**SUBJECT:** Calvert Cliffs Nuclear Power Plant  
Unit Nos. 1 & 2; Docket Nos. 50-317 & 50-318  
Response to Requests for Additional Information for the Emergency Core  
Cooling System Surveillance Requirement Change

In Reference (a), a request was made to revise Surveillance Requirement 3.5.2.8 to reflect the replacement of the containment recirculation sump suction inlet trash racks and screens with strainers. The Nuclear Regulatory Commission staff determined that additional information was needed to support their review of the request (Reference b). Our response to Reference (b) is attached.

**RESPONSE TO REQUEST FOR ADDITIONAL INFORMATION**

UNIT 2  
CCI STRAINER LAYOUT  
REDLINE DRAWING

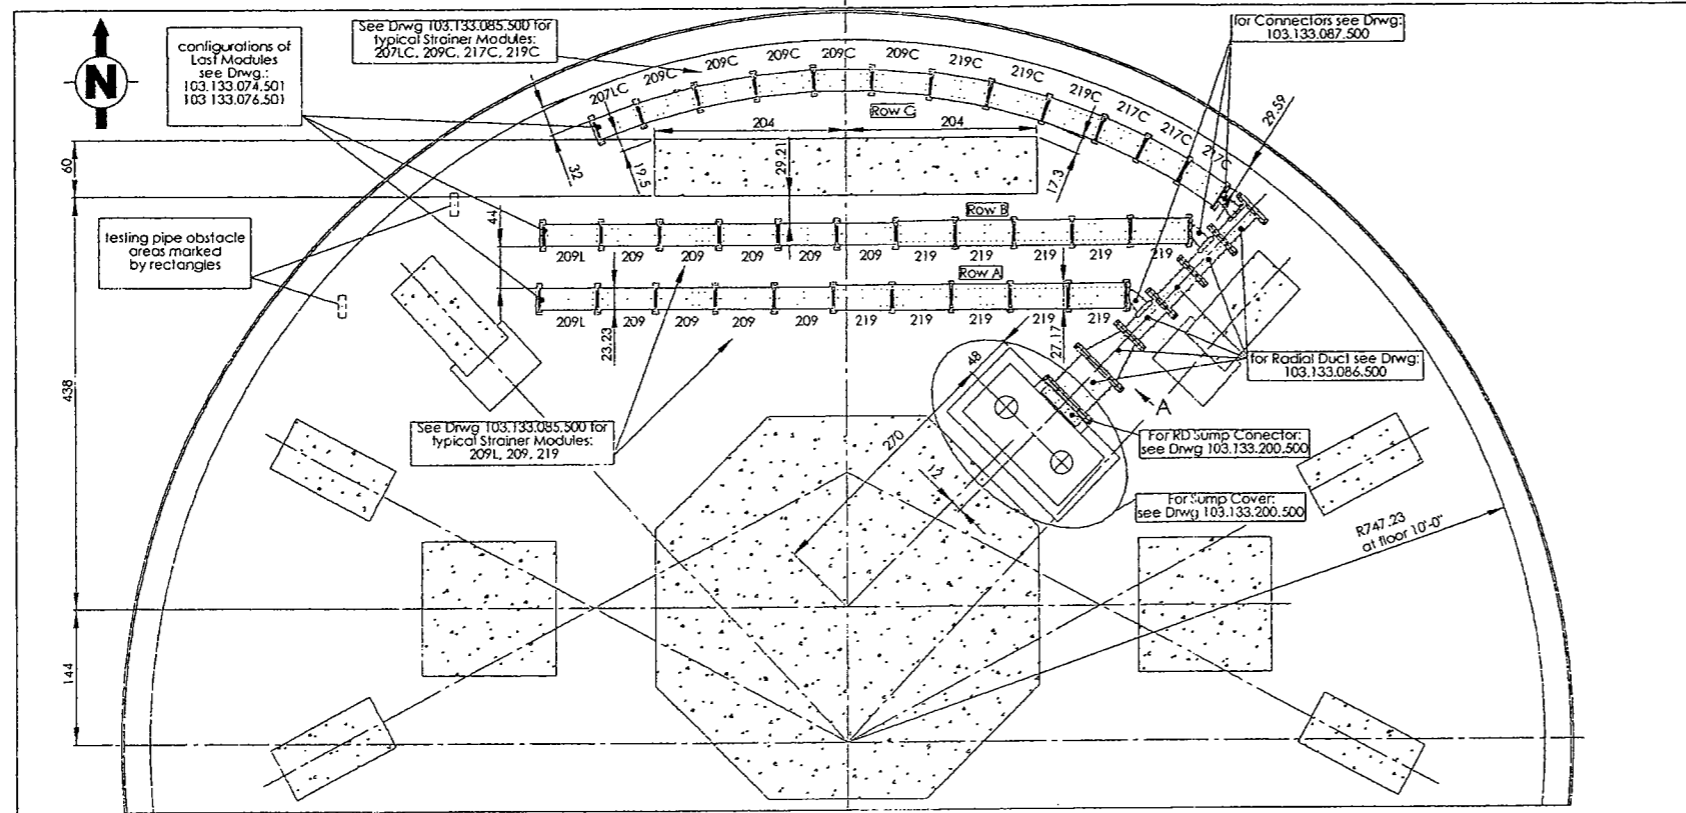
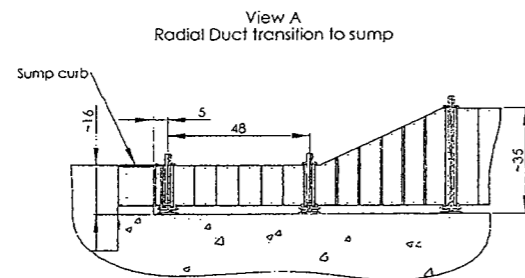
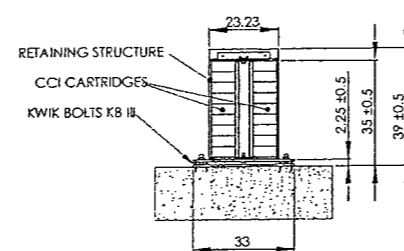
Provide Information showing the layout of the new strainer arrangement and its support system.

See Enclosure (1), which provides a drawing showing the strainer layout and a drawing of the strainer module anchor system.
